Change No. 11
License Nos. DPR-31 and 41

Change No. 11
License Nos. DPR-31 and 41

SAFETY EVALUATION FOR OPERATION OF TURKEY POINT UNITS 3 & 4

AT POWER LEVELS UP TO 100% OF RATED AND AT REDUCED PRIMARY SYSTEM PRESSURE

Figure 2.1-1. Reactor Core Thermal and Hydraulic Safety Limits, Three Loop Operation.

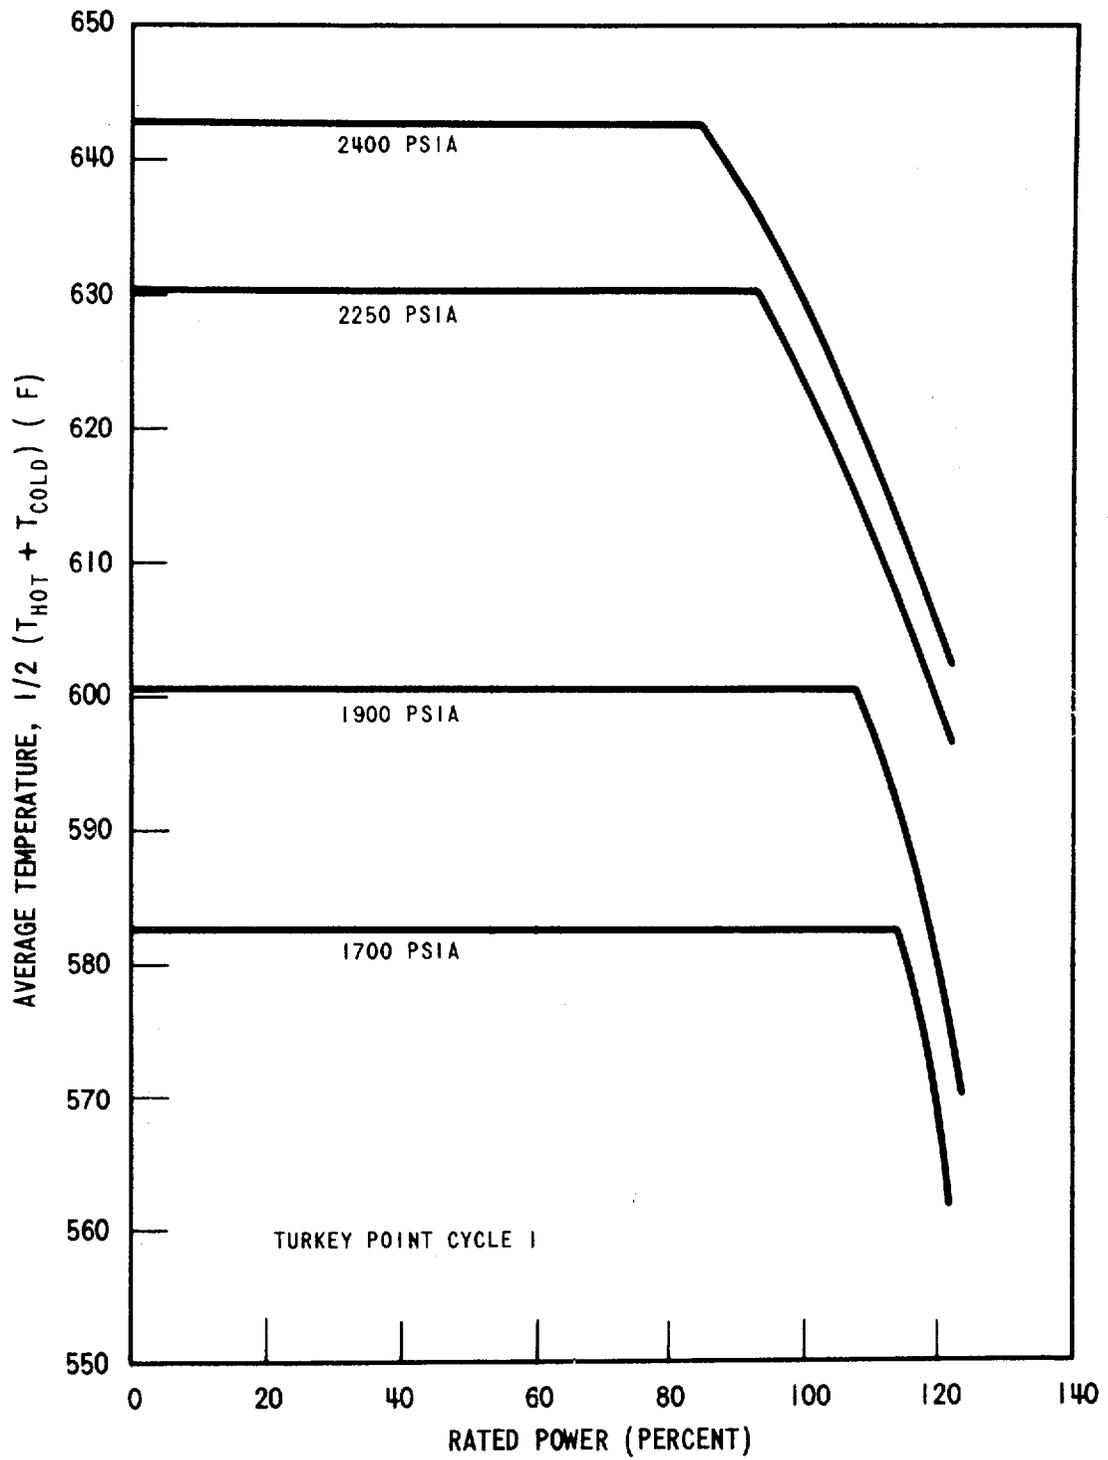
Changes to the limiting safety system settings have been made in Section 2.3 to reduce the low pressurizer pressure trip setting, and to revise the overtemperature and overpower ΔT trip settings in accordance with revised Figure 2.1-1. Changes to Section 3.2, Control Rod and Power Distribution Limits, have been made to paragraph 5, Power Distribution Limits, to define the allowable operating power and required power distribution measurements in accordance with Figure 3.2-4.

Figures 2.1-1 and 2.1-2

These are replacement figures.

Figure 3.2-3 Maximum Allowable Operating Power Level versus Fuel Burnup

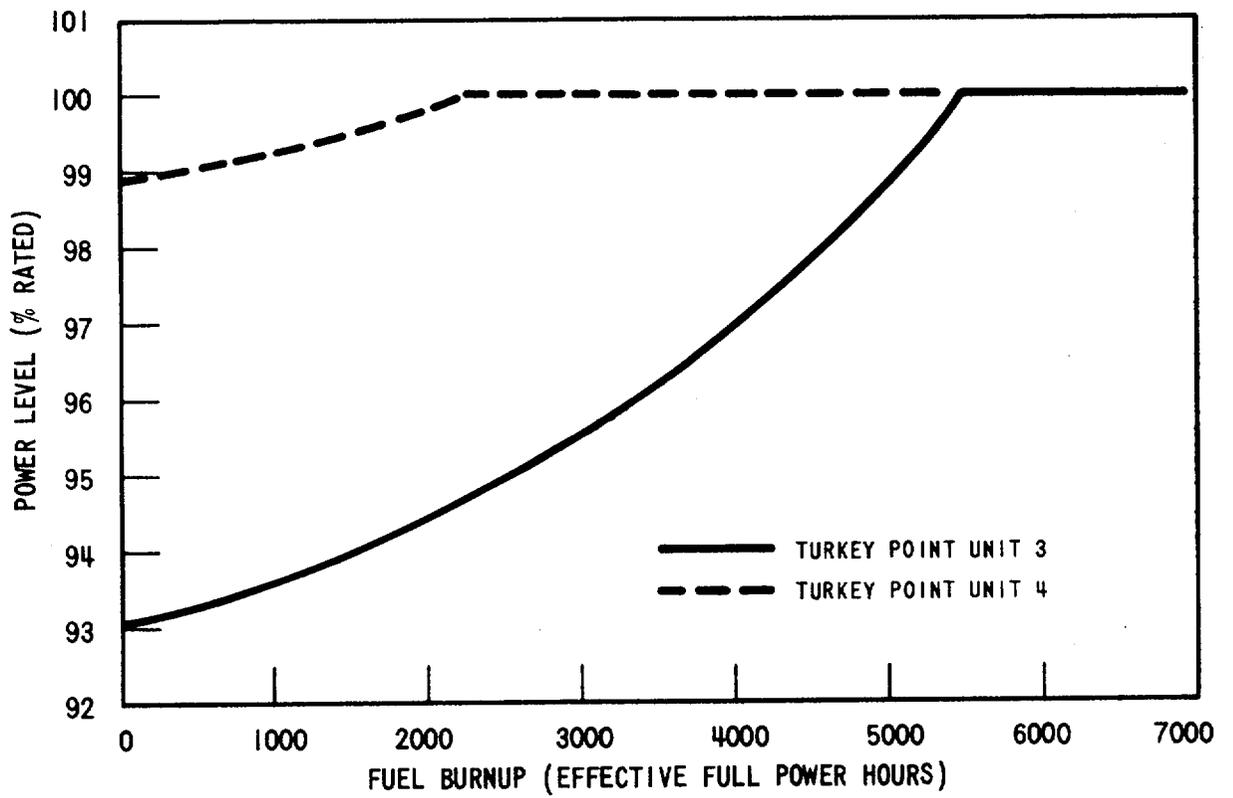
Figure 3.2-3 (new) has been added to the list.

Figures 3.2-3 and 3.2-4

These are new figures.

- c. The permissible fraction of rated power, N, not to exceed the power levels given in Figure 3.2-3, at which the reactor can be operated shall be determined by

Figure 3.2-4. Maximum Allowable Local KW/FT

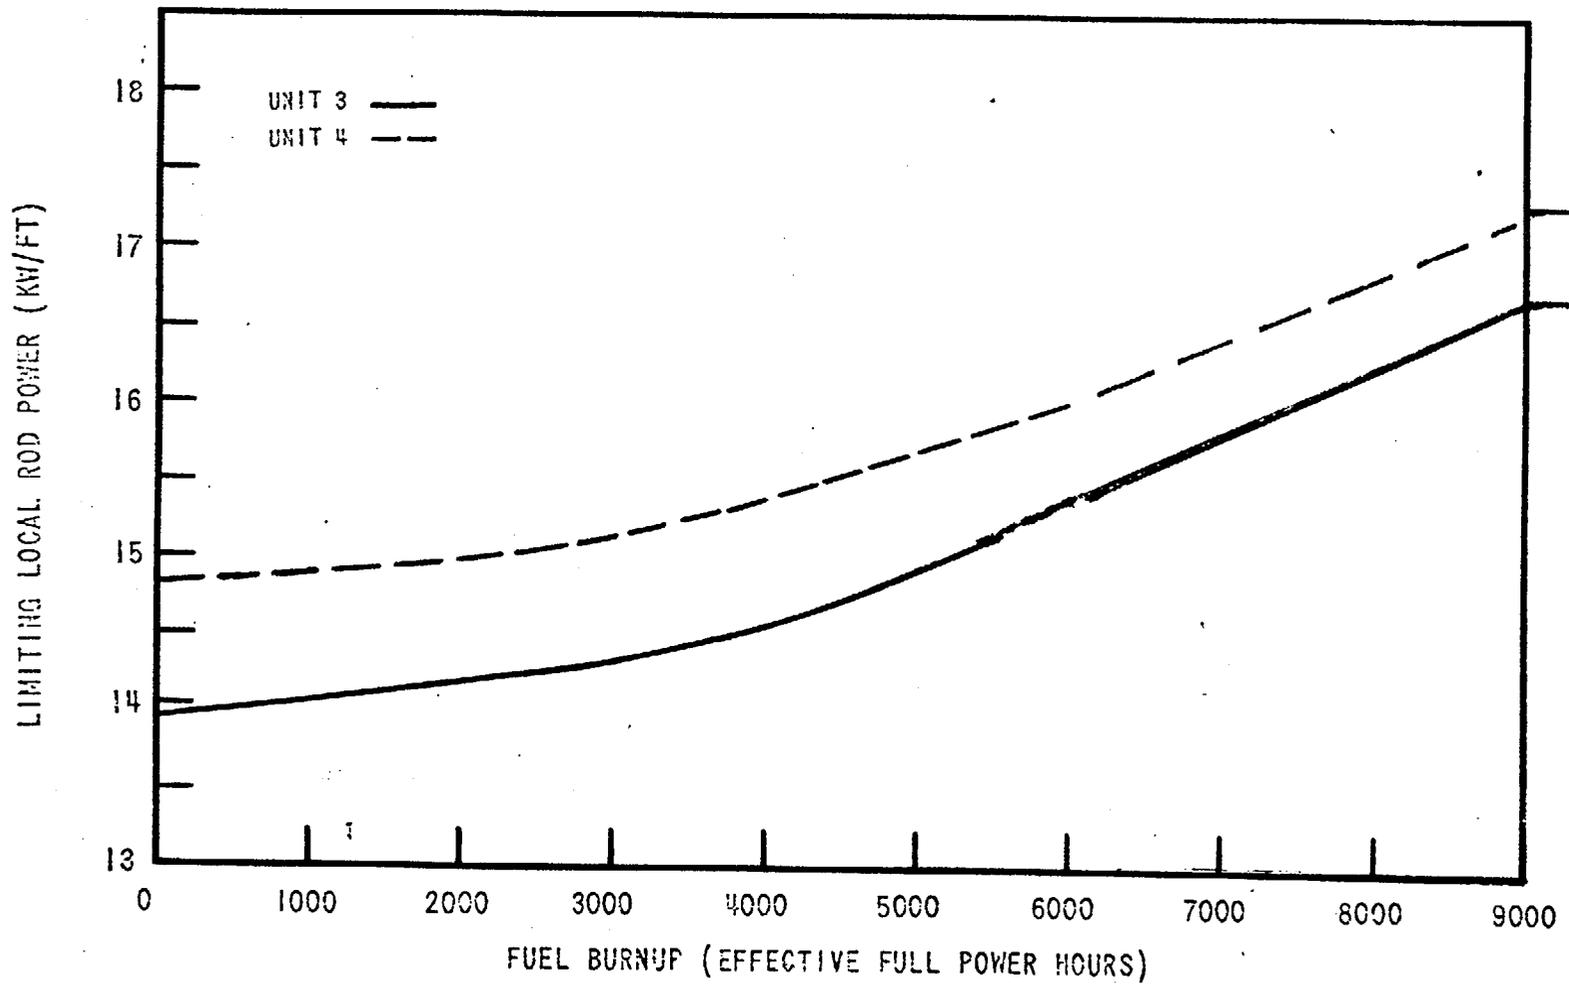
Figure 3.2-4 (new) has been added to the list.
